**ADDENDUM #01**

Date of Addendum: December 15, 2020

SOUTH CAMPUS S1 PARKING GARAGE REPAIRS - ELECTRICAL SYSTEMS

207036 - South Campus S1 Parking Garage Repairs - Electrical Systems

E6.00

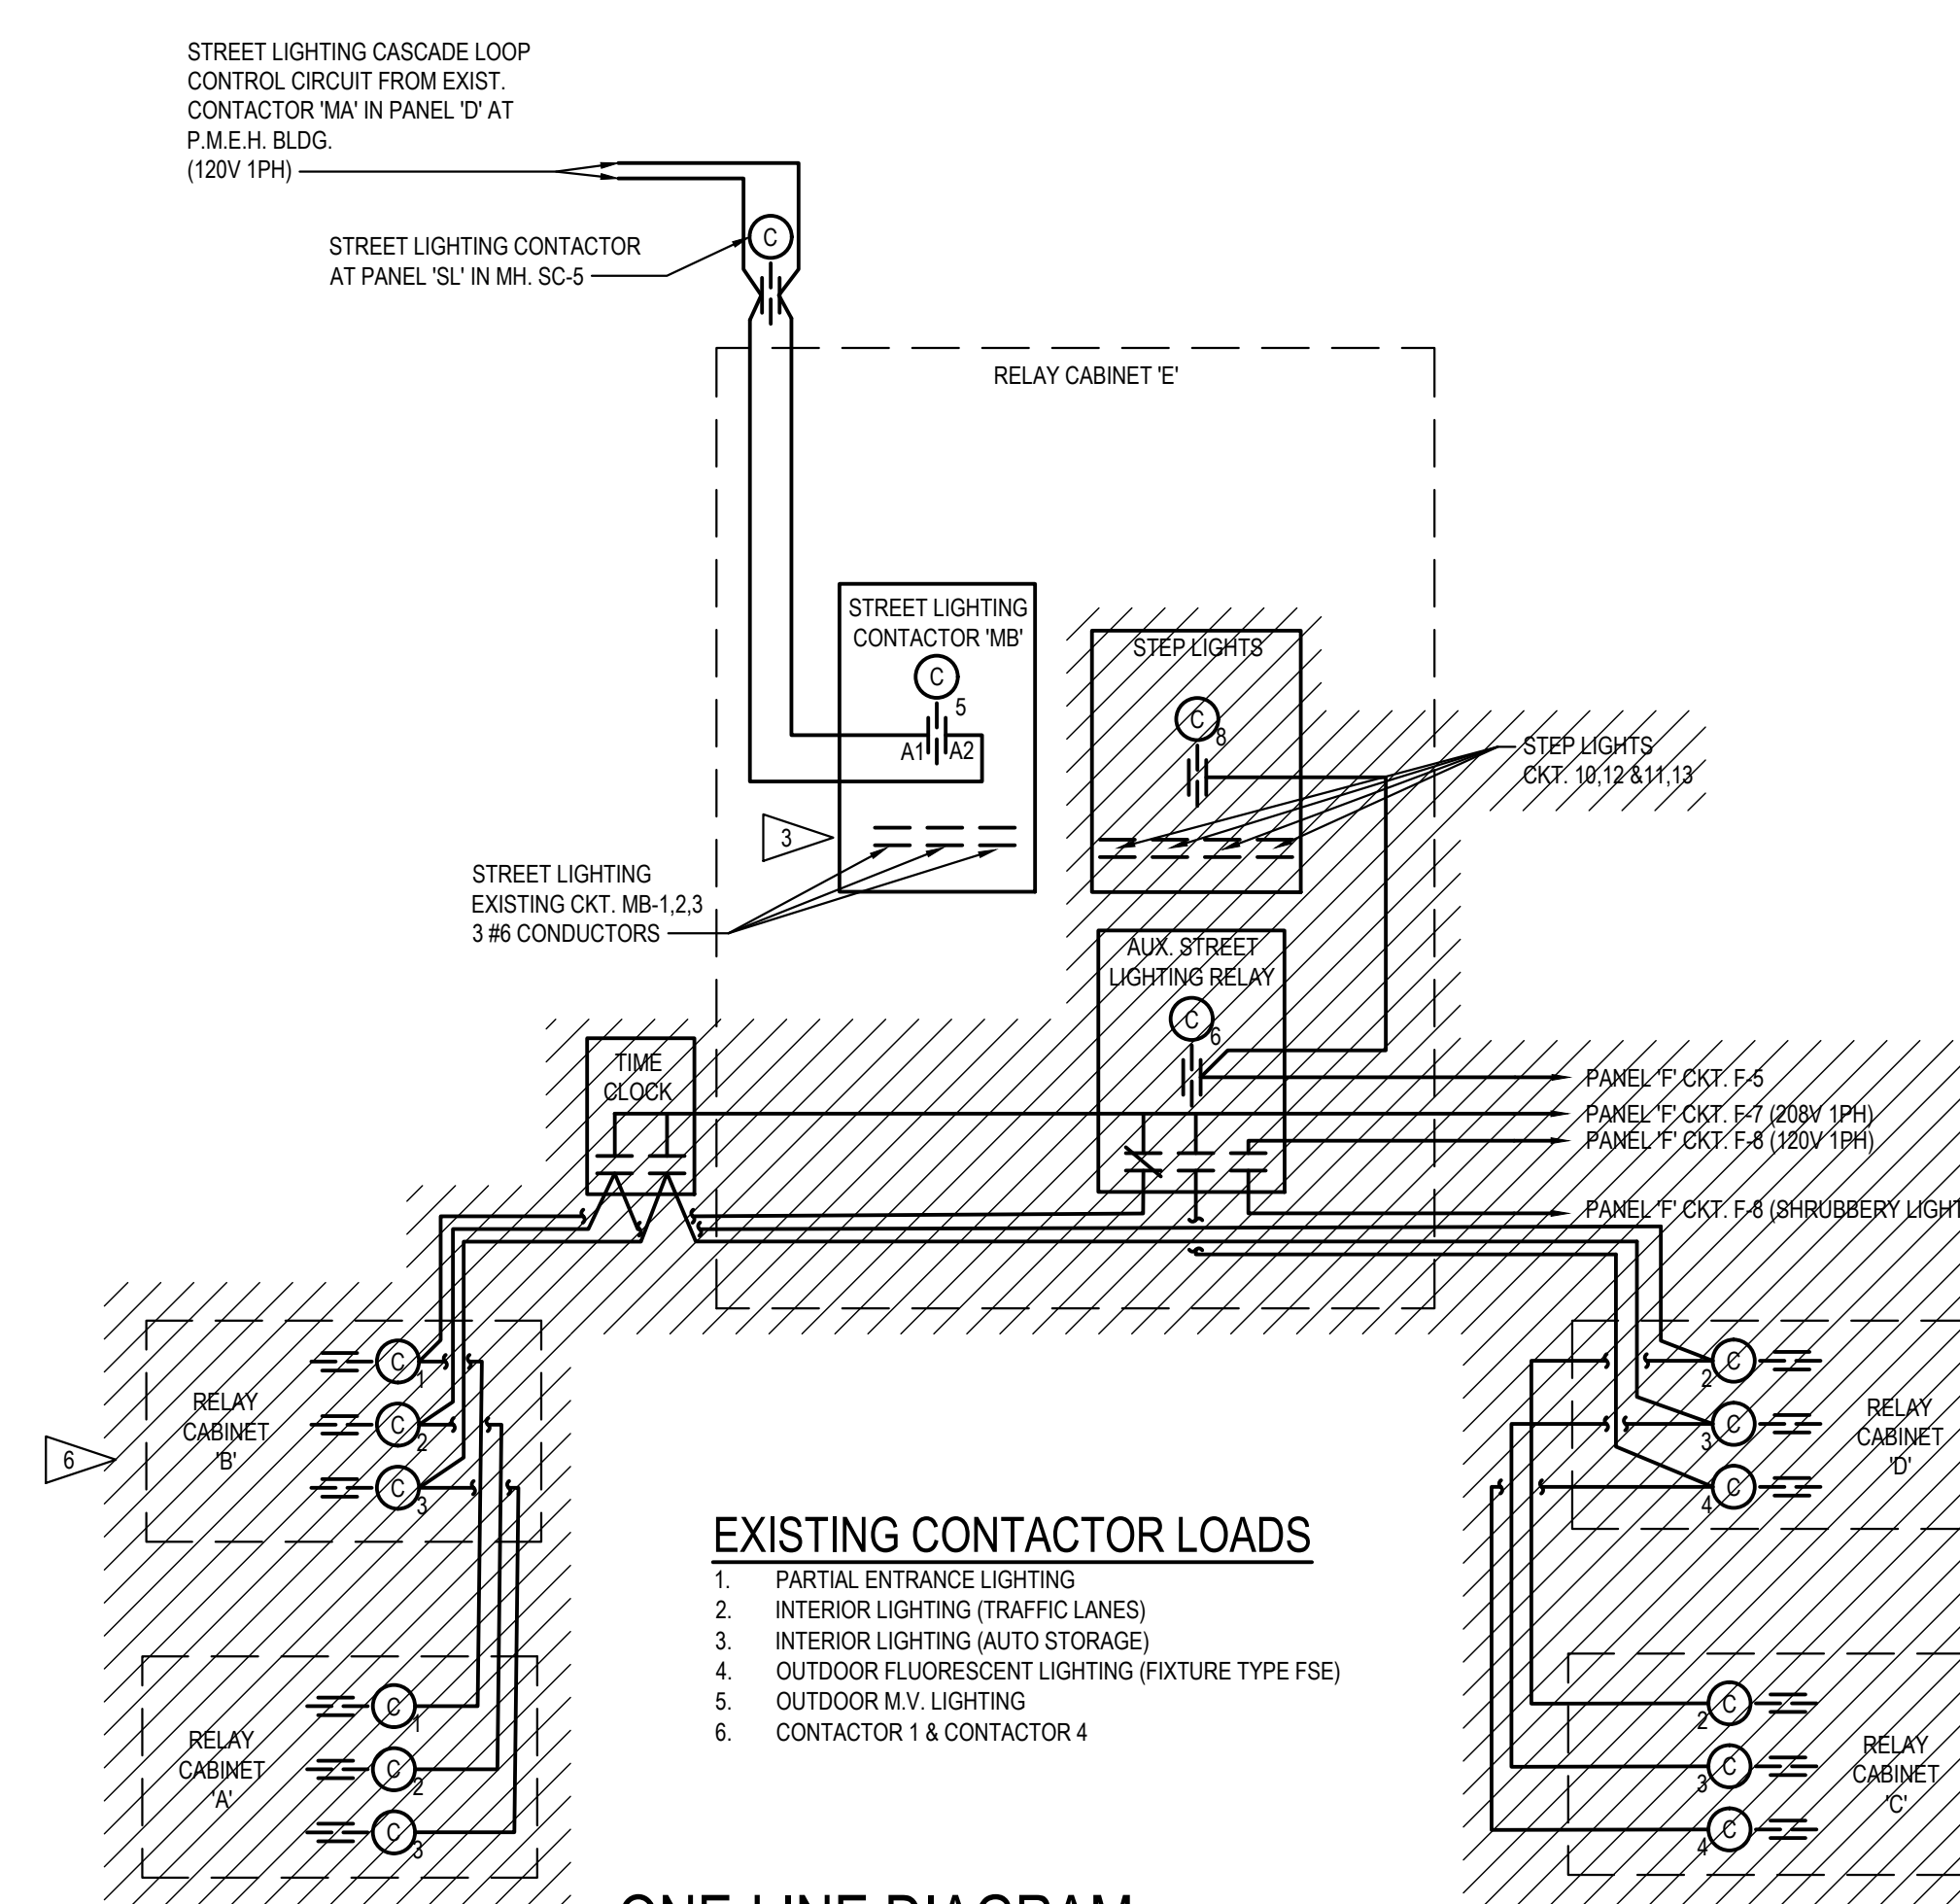
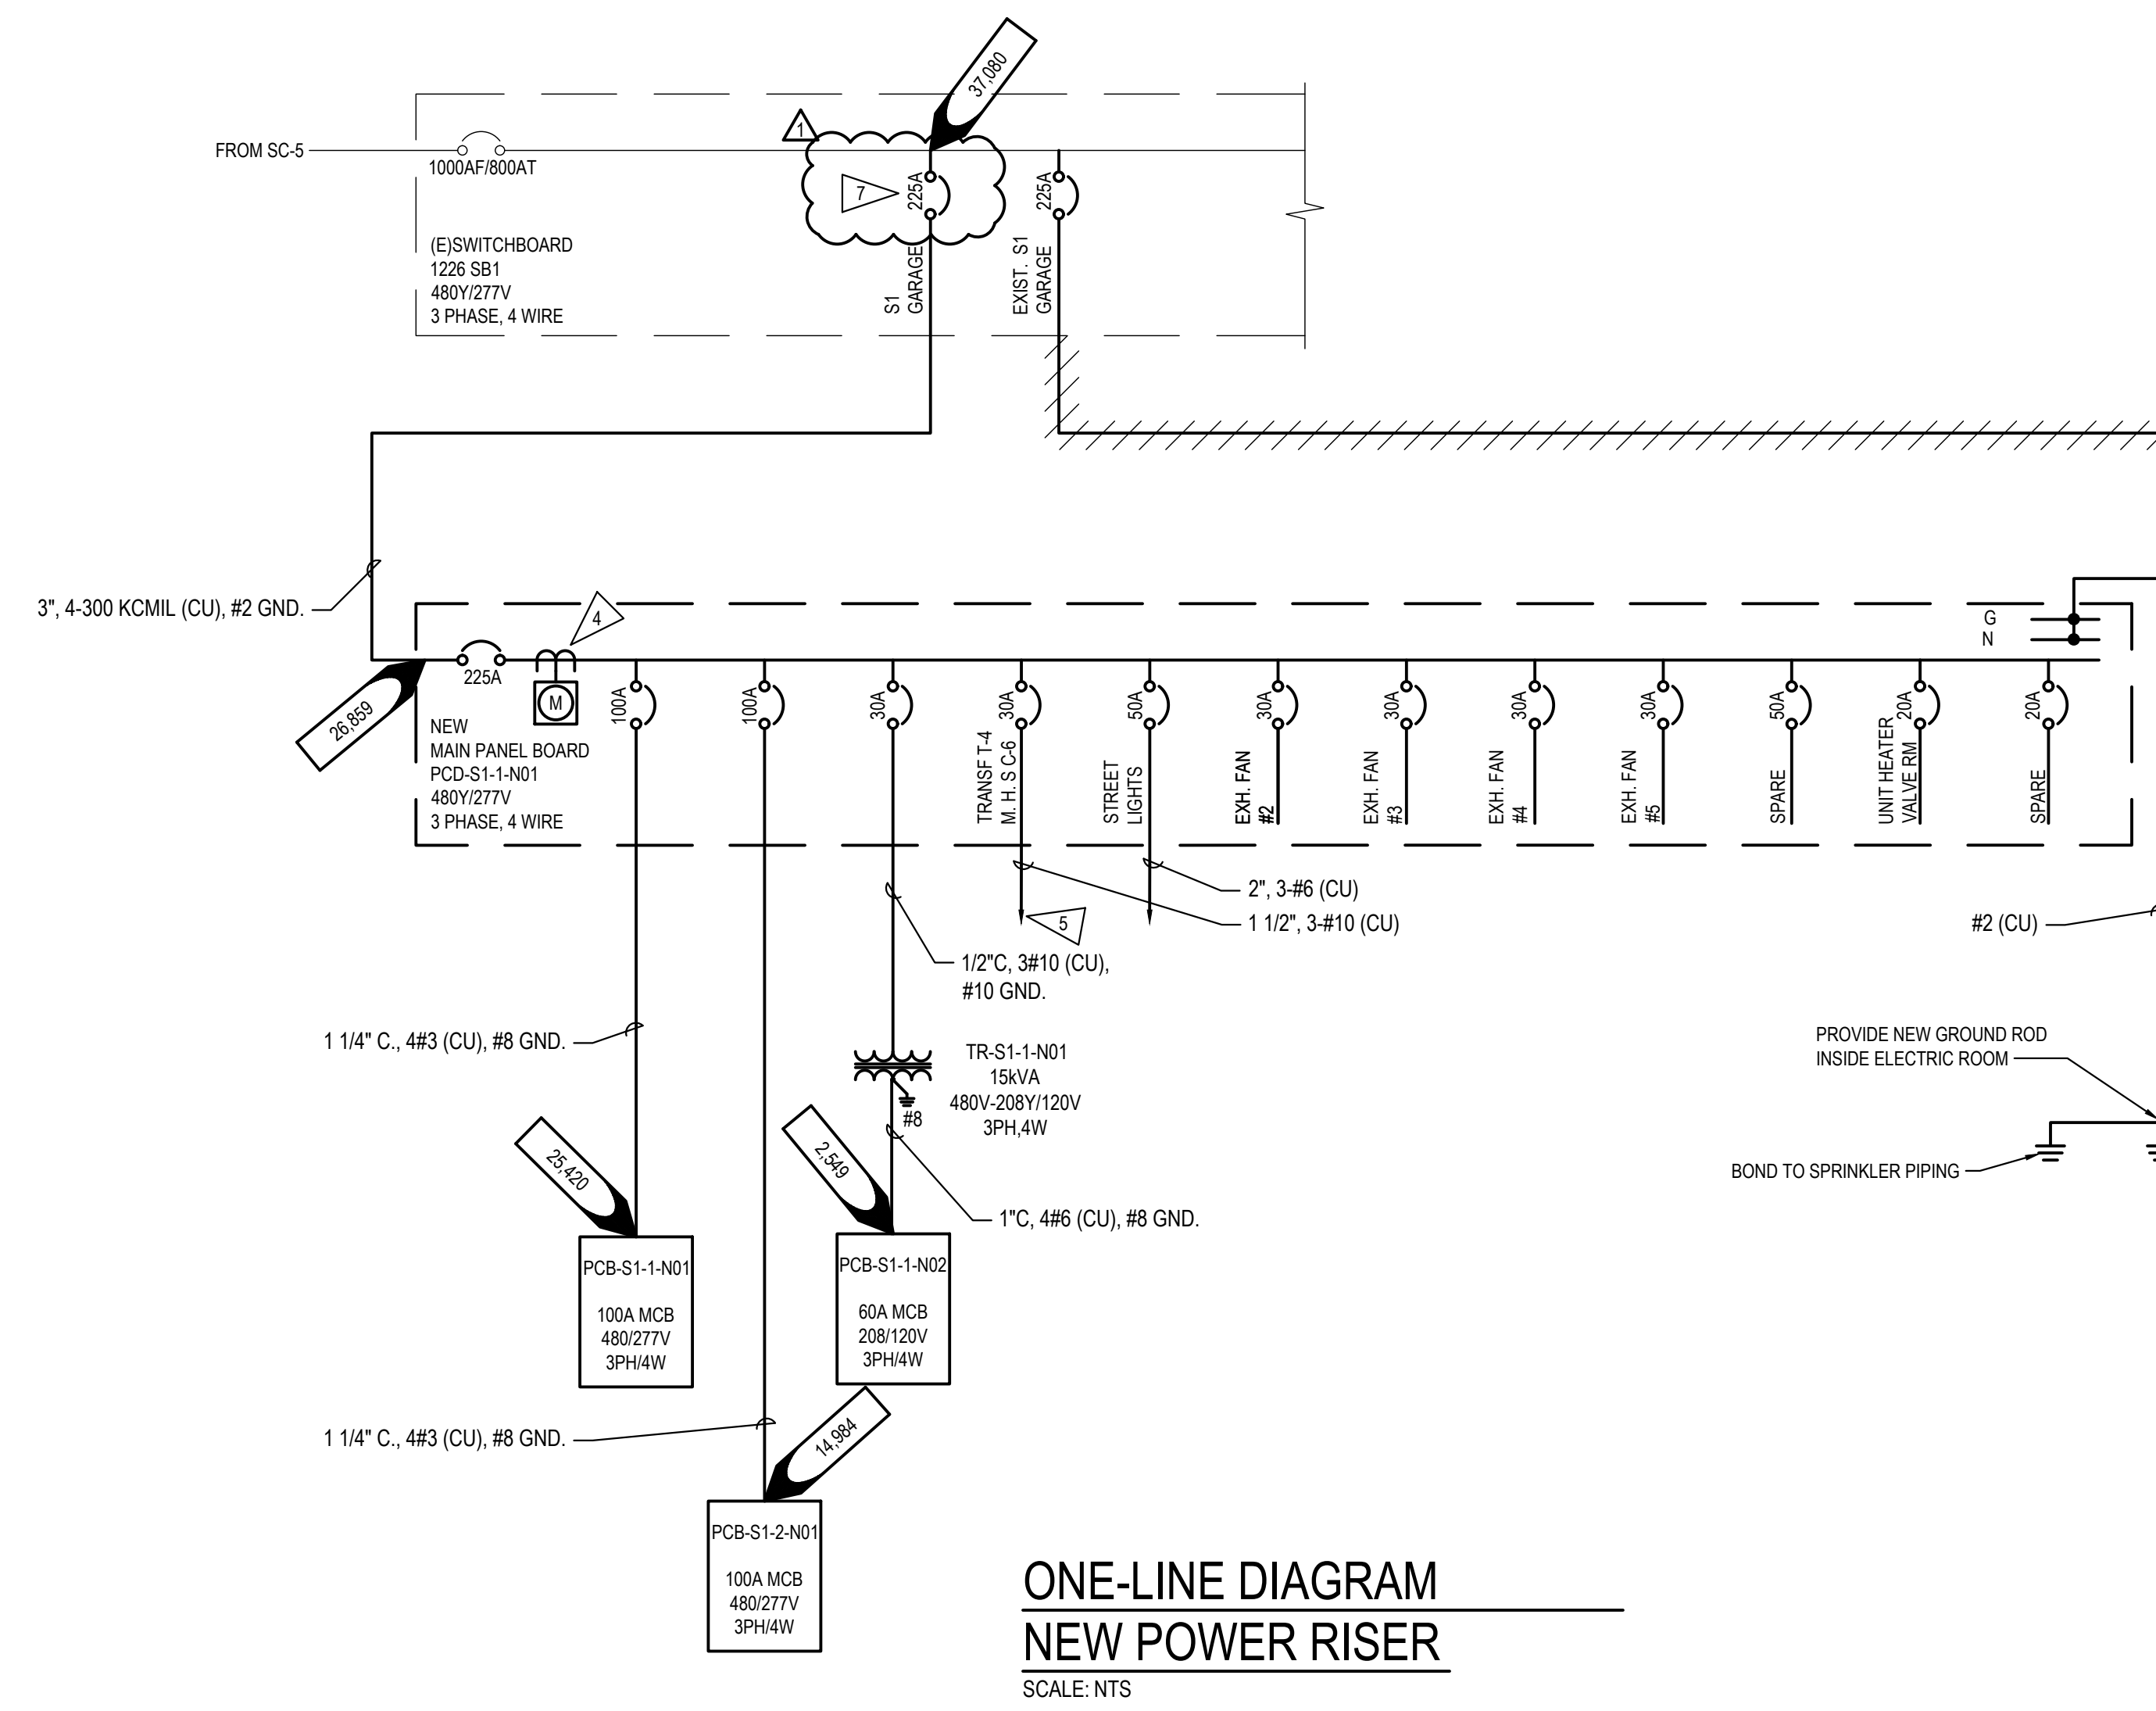
Item	Drawing No.	Description of Change
4.1	E6.00	Replace E6.0 to include the addition of requirement for testing of existing circuit breaker in switchboard 1226 SB1. See the revised E6.0 that is attached to this Addendum.

- 6. DEMOLISH THE EXISTING CONTACTORS AND WIRING.
- 7. PROVIDE TESTING OF THIS EXISTING CIRCUIT BREAKER PER SPECIFICATION SECTION 26 24 16. 3.4
